TIERRA WEST, LLC

**RE: LOT 2A & 3A DEL NORTE PLAZA
GRADING AND DRAINAGE PLAN
ENGINEER'S STAMP DATE 2-17-2016 (C18-D042D)**

DRAINAGE REPORT

Lot 2-A and 3-A Del Norte Plaza

SECTION A-A
NTS

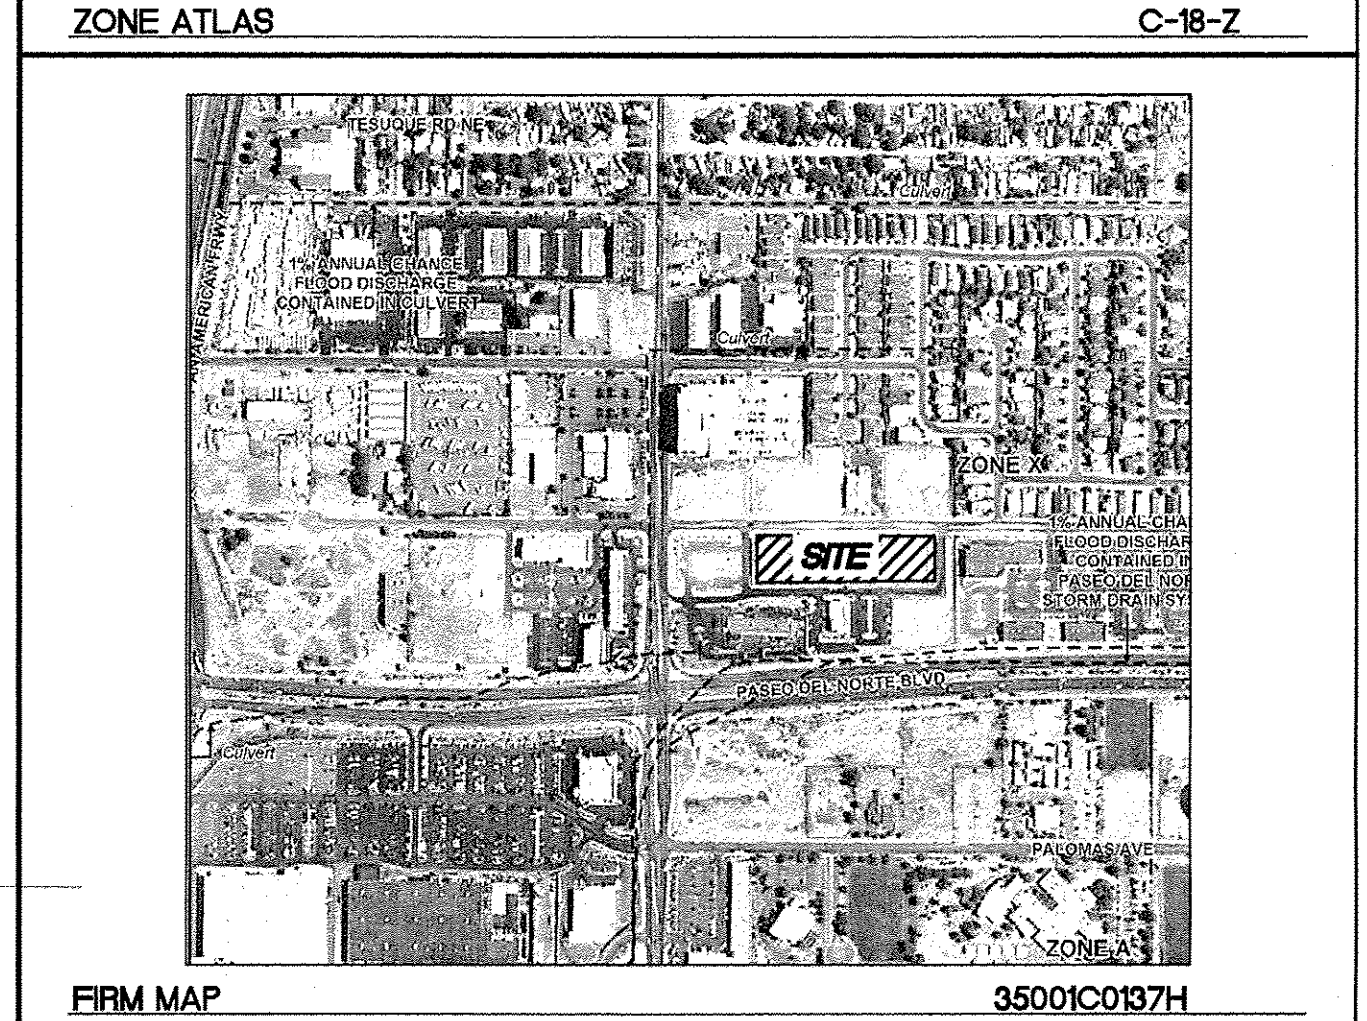
6. Label the intended cross slope of the sidewalk on Section A-A.

Response: The cross slope of the sidewalk has been called out on Section A-A as 1.0% sloped towards the trench drain.

DETAIL B - TRENCH DRAIN DETAIL
NTS

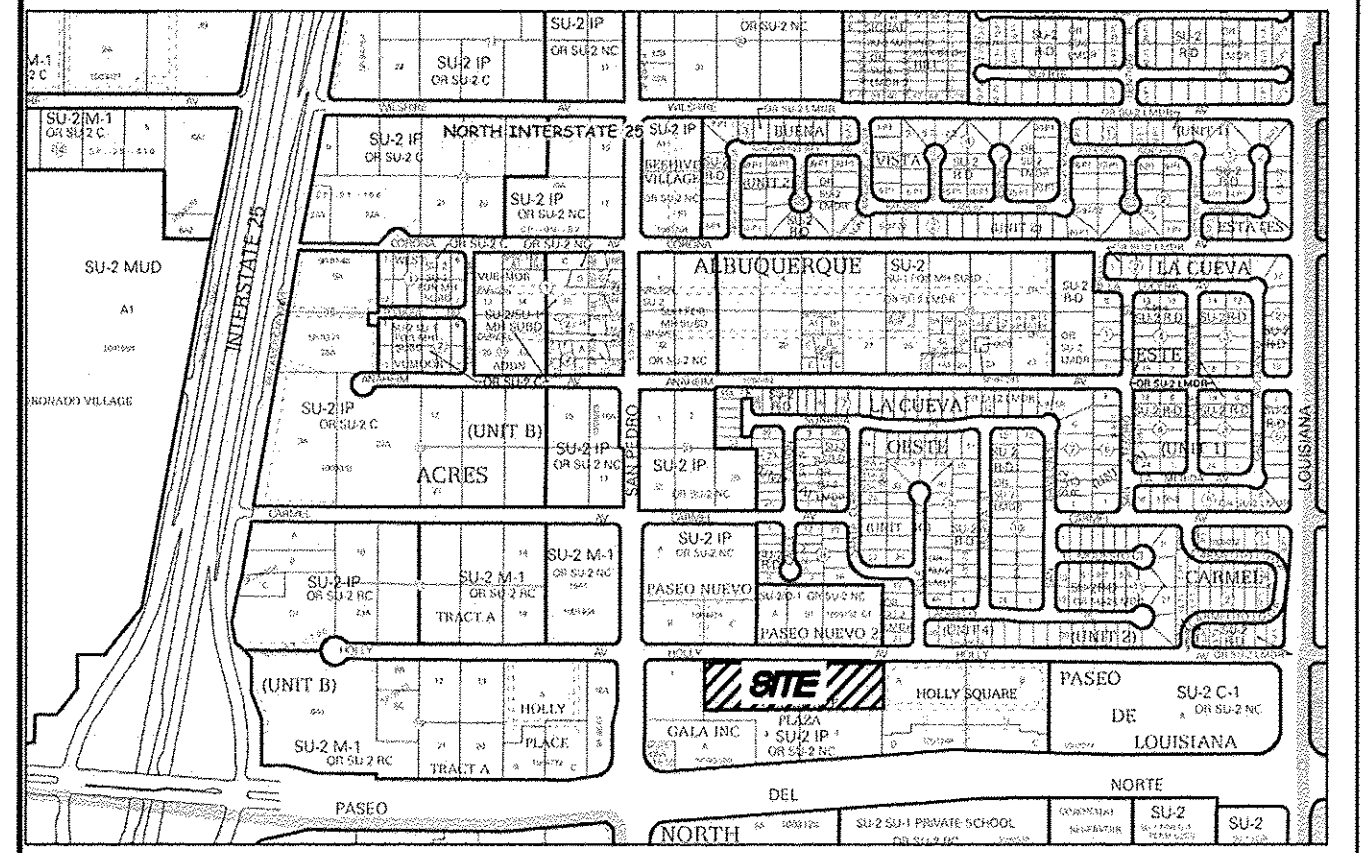
5. Detail B describes the use of a trench drain to provide an outfall for the roof drains of the larger building. A type of grate should be called out that complies with ADA standards and is "heel safe", since it is proposed along the center of the sidewalk. If the sidewalk is intended to drain to the west (without needing to enter the trench drain) we recommend calling out a solid metal top.

Response: As discussed with you on the phone, Section A-A has been updated to call out the metal grate to be ADA compliant and "Heel Safe". Because the sidewalk would be draining into the trench drain, the metal grate has also been called out to be an open grate.

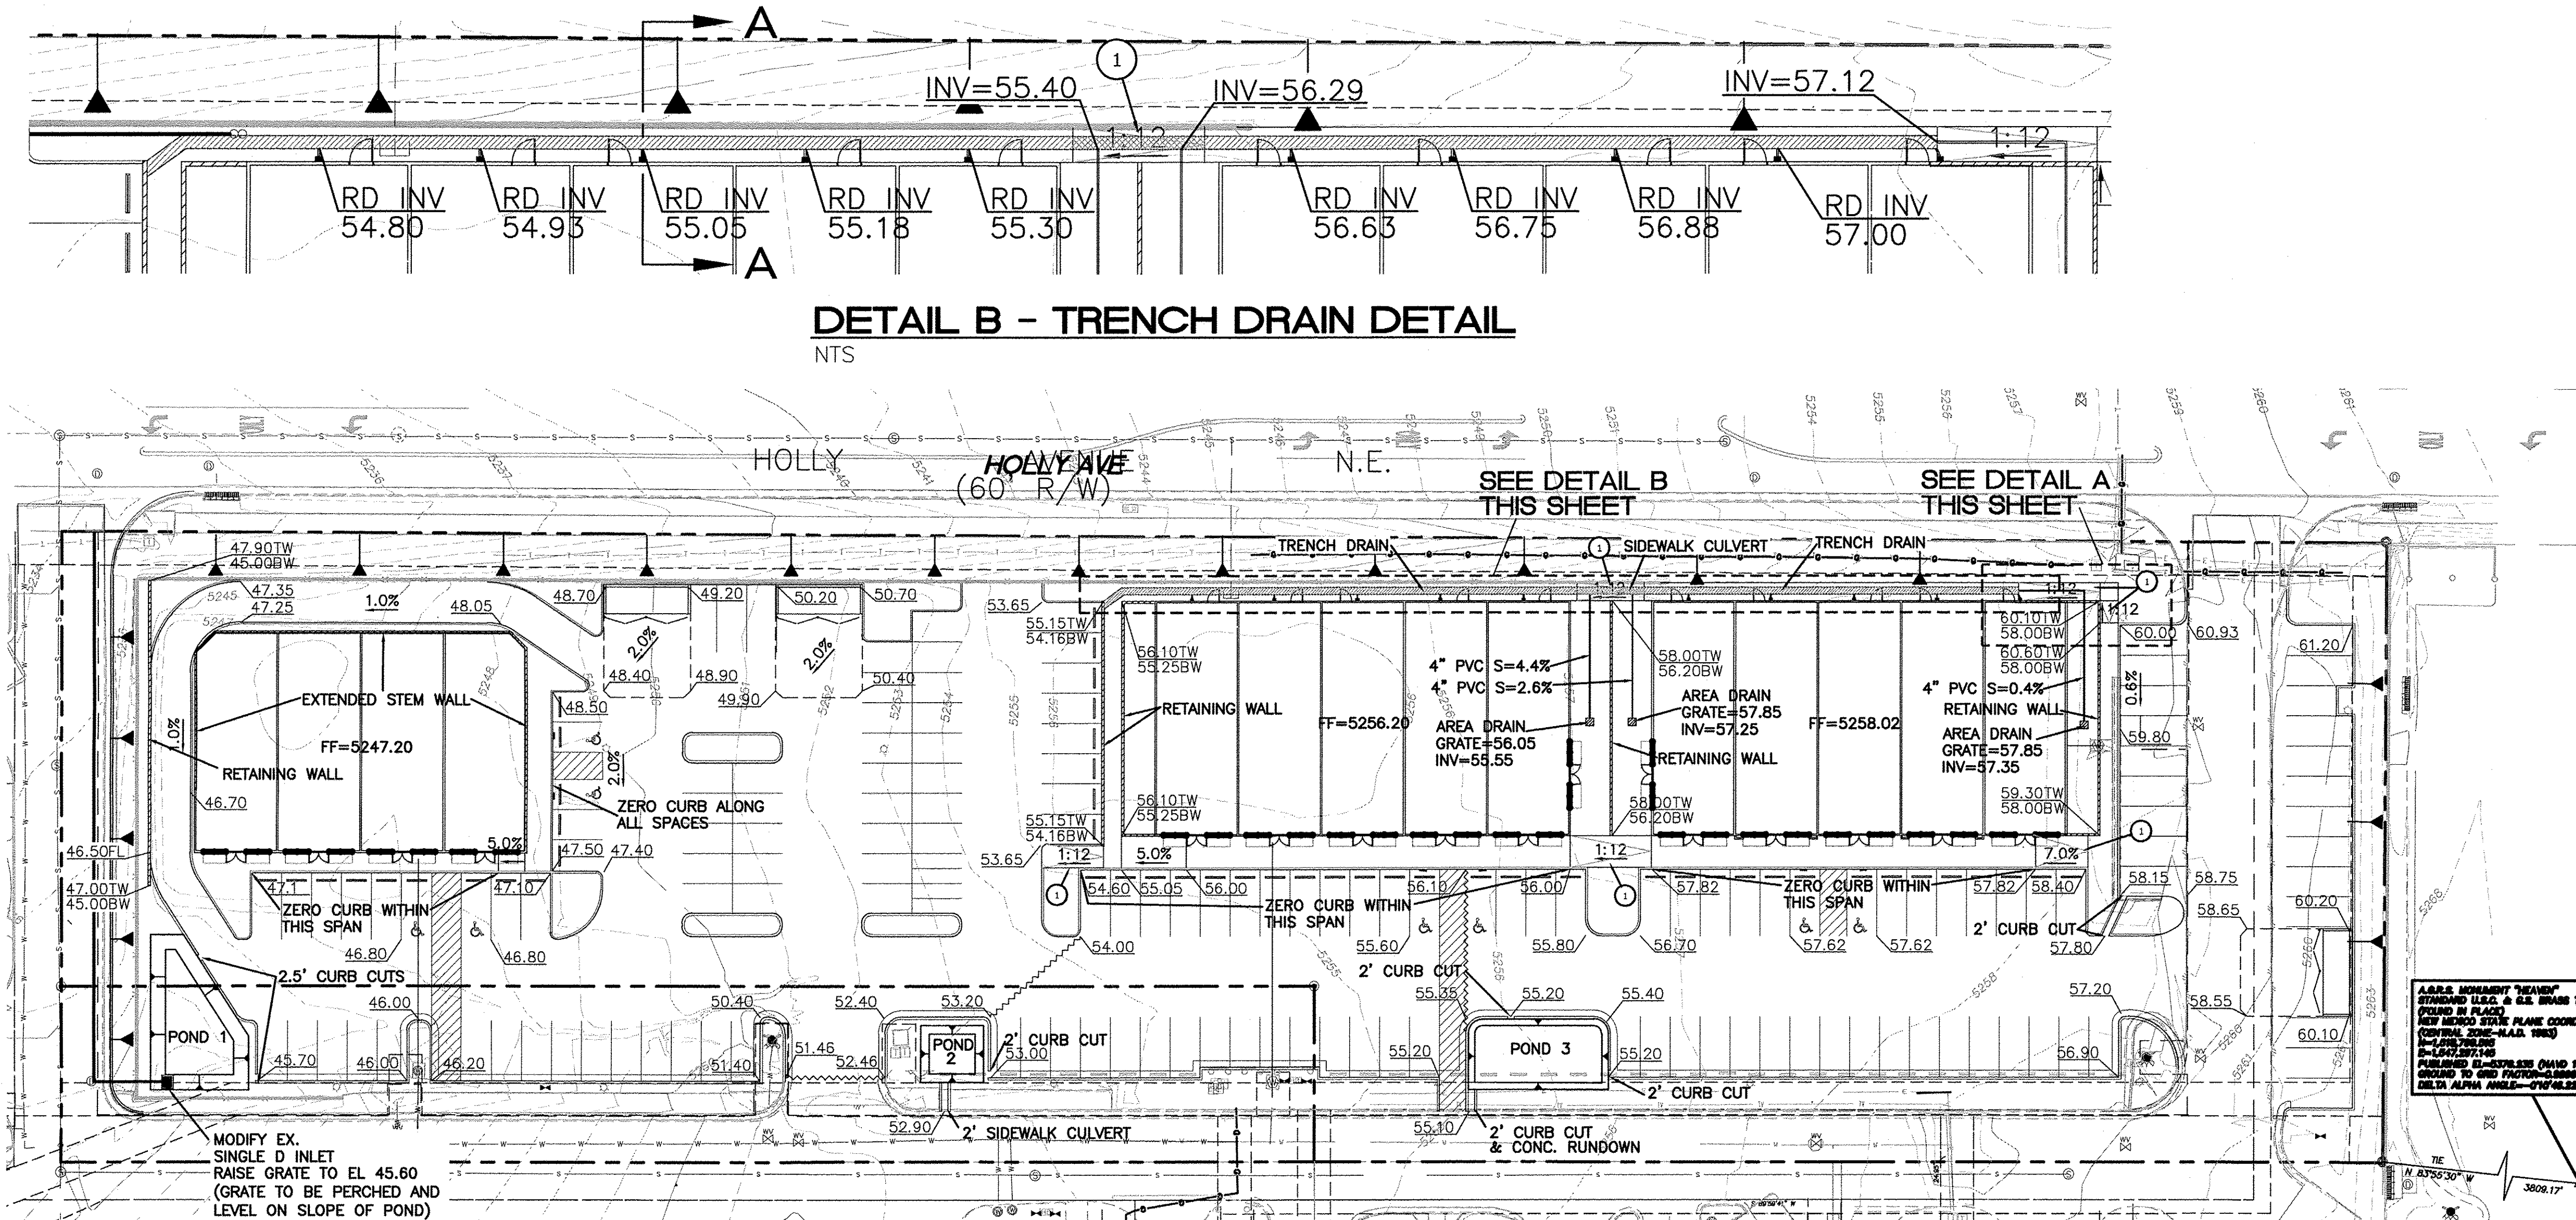
3. The existing inlet in the proposed "Pond 1" is called to be modified. Clarify what the modification involves.
 - a. The grate is shown on the slope of the pond; it is assumed that the box will be perched to ensure that the inlet elevation is level and set at EL 45.60 as called out.

7. We recommend shifting the 12:1 wheelchair ramp that is in front of the easternmost retail space of the larger building slightly to the west so that the top of the ramp lines up with the parking curb; this would remove a potential tripping hazard and provide a better turning space for wheelchairs at the top of the ramp.

Response: The modification to the existing inlet is to raise the grate elevation from 42.45 to 45.60. This modification has been called out on the plan to be raised and perched.

Response: The wheelchair ramp in the mentioned location has been shifted slightly towards the west to line up with the parking curb.
